MIL-M-21393A(AS)
Amendment-6
15 November 1968
Superseding
Amendment-5
1 July 1967

MILITARY SPECIFICATION

MICROPHONE, DYNAMIC M-92C/U

This amendment forms a part of Military Specification MIL-M-21393A(WEP) dated 1 July 1960 and has been approved by the Naval Air Systems Command, Department of the Navy.

FIGURE 1A Hand-held microphone M-92C/U

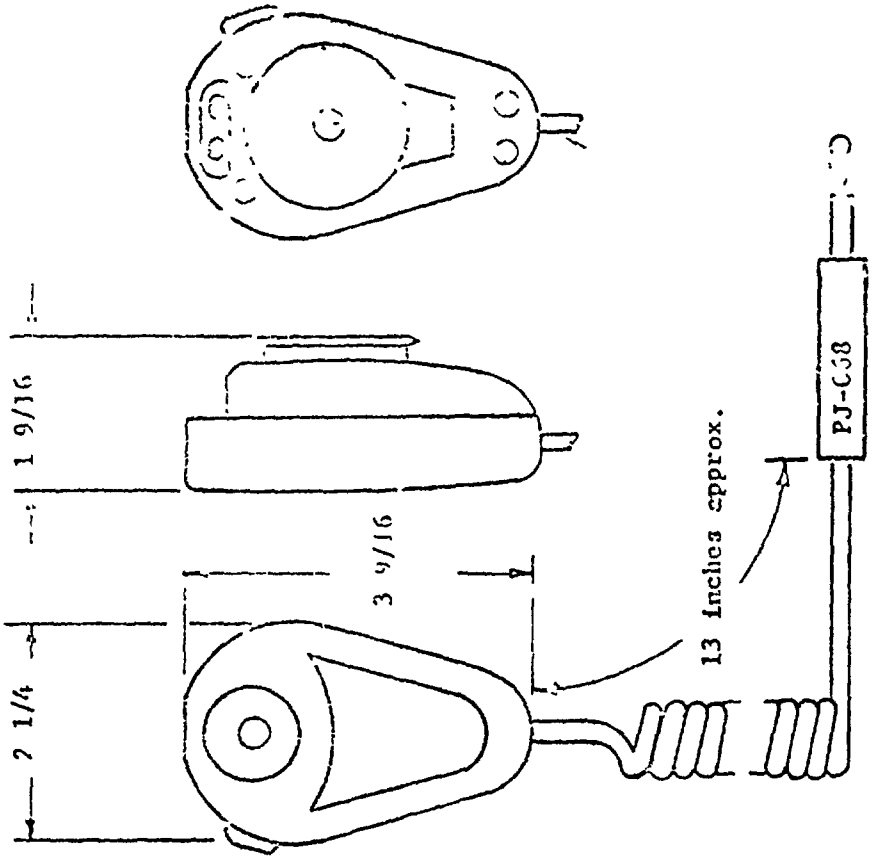
Page 3, paragraph 3.3.5, first sentence: Add

"or Figure 1A"

Page 5, paragraph 3.4.1.2: Add

"or Figure 1A"

Page 14, Add

"6.4 Ordering Data - The procurement document should specify the title, number and date of this specification and configuration in accordance with either Figure 1 or Figure 1A of this specification."

Figure 12. Frequency Response

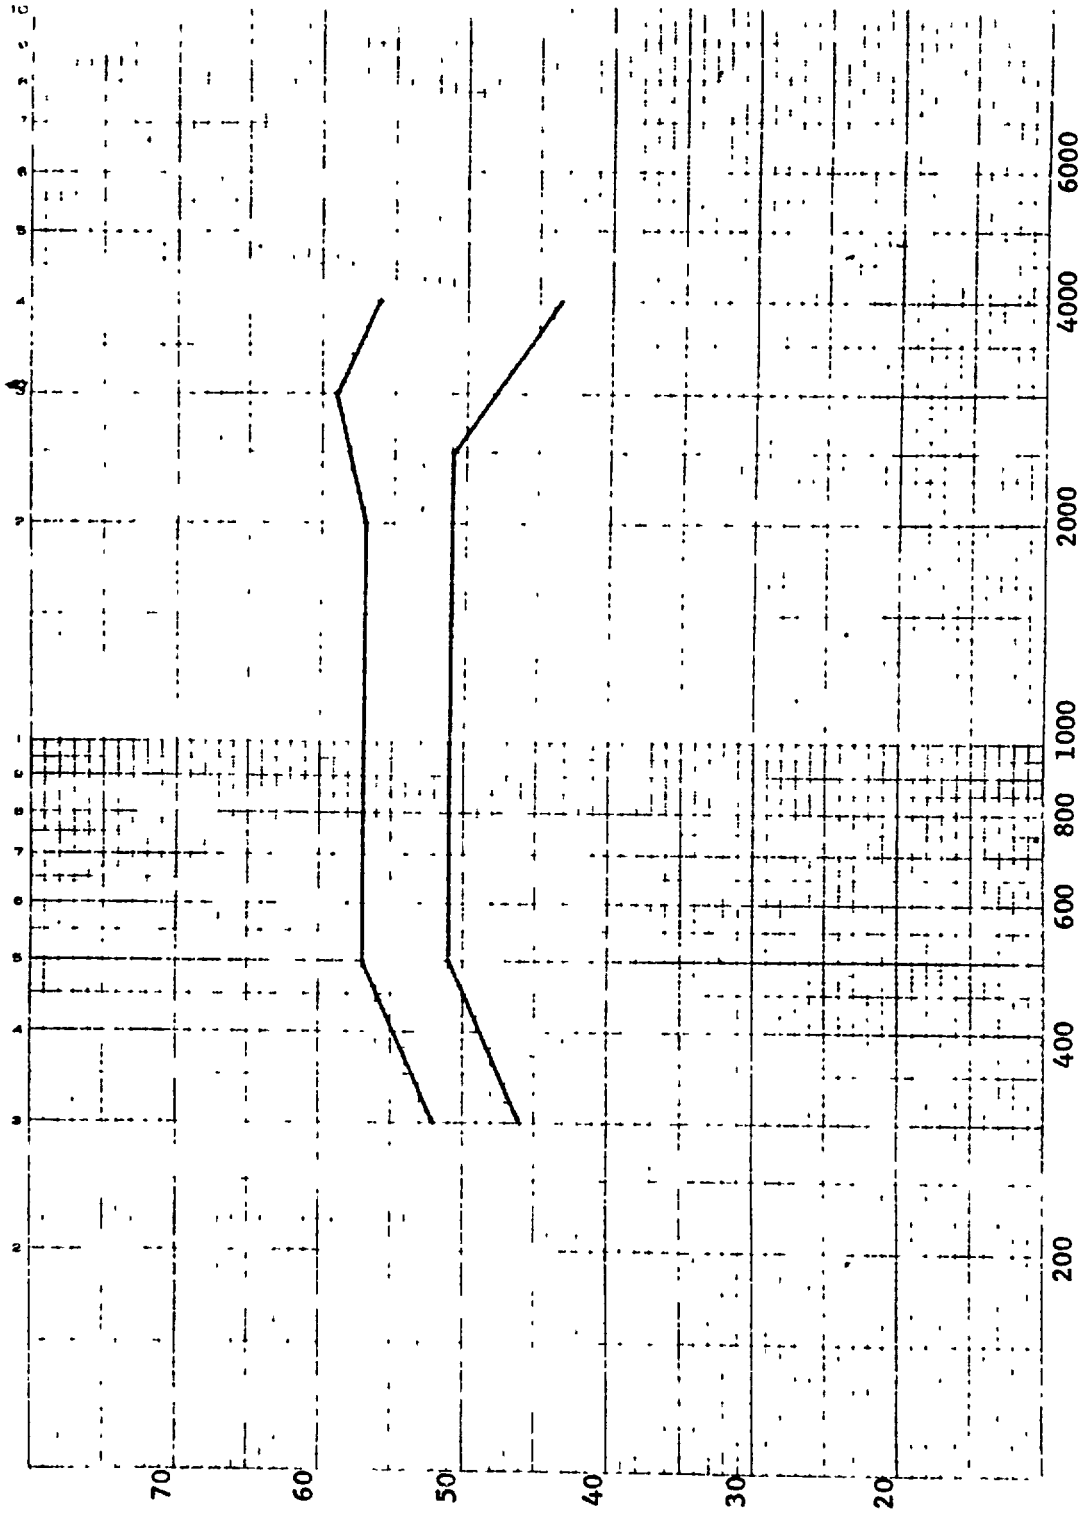
Page 5, paragraph 3.5.2: Delete "Table I" and Substitute

"Figure 12"

Page 9, paragraph 4.5.3.2: Delete "3.5.2 Table I" and substitute

"Figure 12"

FIGURE 13 RADIATED RADIO FREQUENCY SUSCEPTIBILITY TEST CIRCUIT

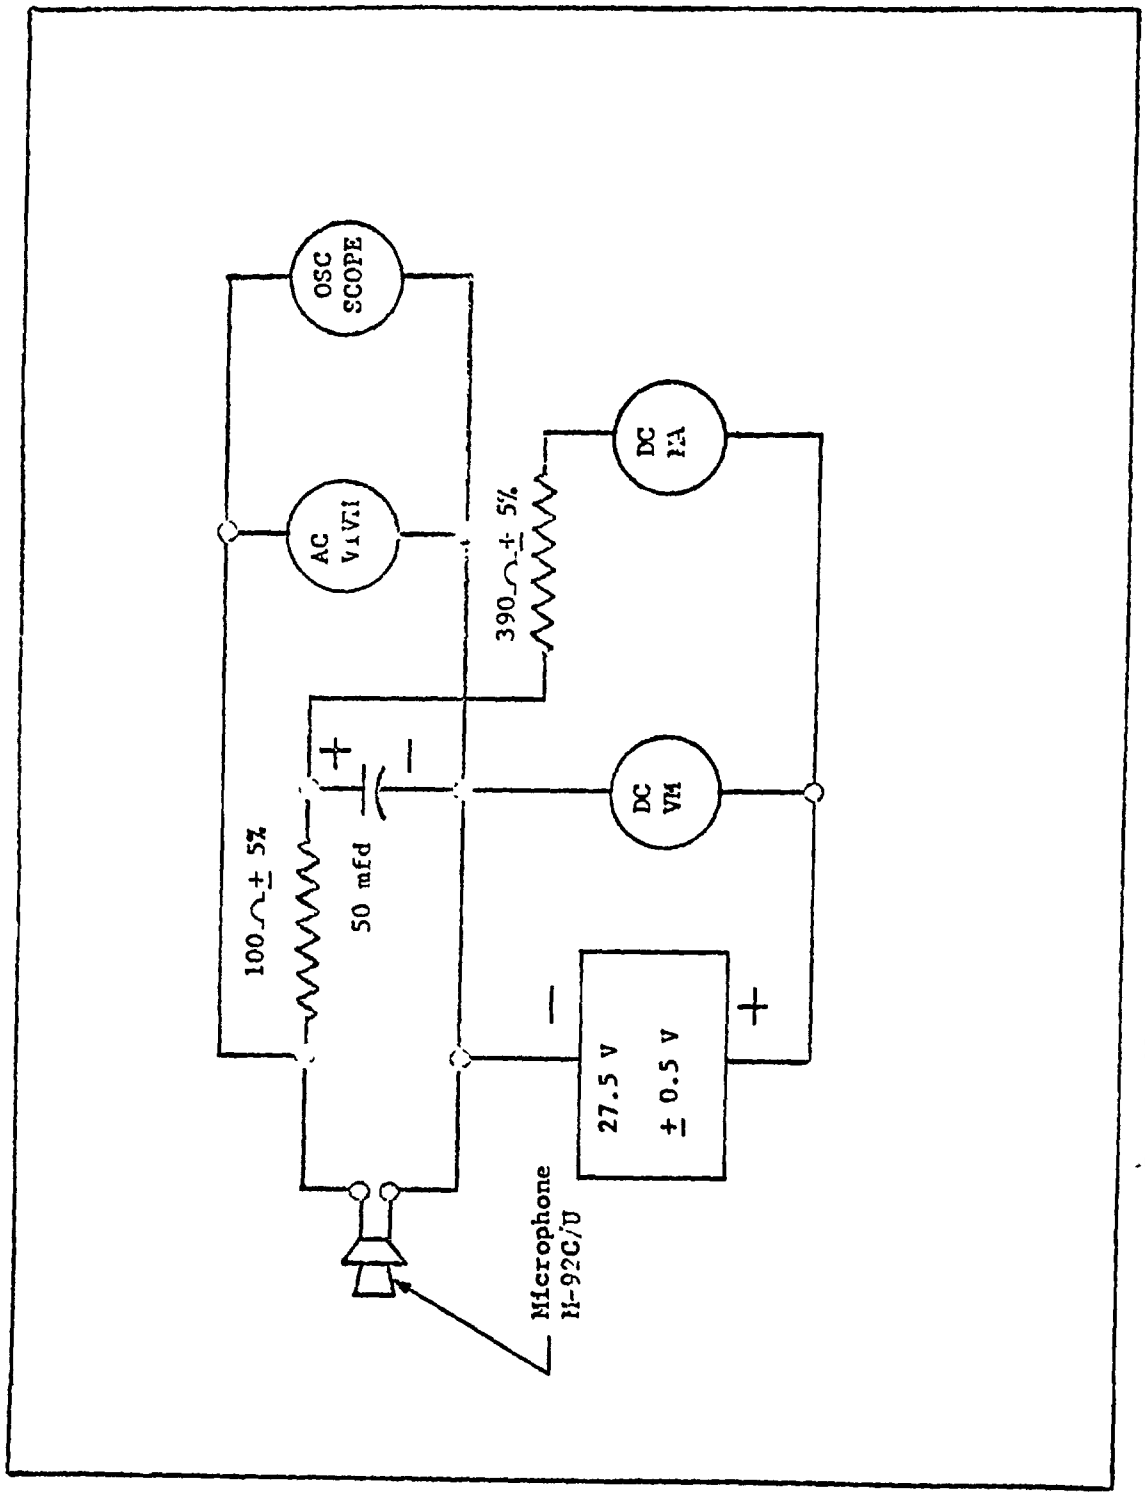
Page 6, Add "3.5.11 Susceptibility

3.5.11.1 Radiated R.F. Susceptibility - The microphone, when connected as shown in Figure 13, shall not evidence oscillation or other degradation of performance including extraneous signals or noise (i.e. output which does not correspond to a desired input) when subjected to any frequency and steady field intensity shown in Table V. The microphone shall not evidence oscillation or other degradation when subjected to the required steady field intensity for a period of three minutes at nine frequencies including end and mid frequency of each frequency band of Table V."
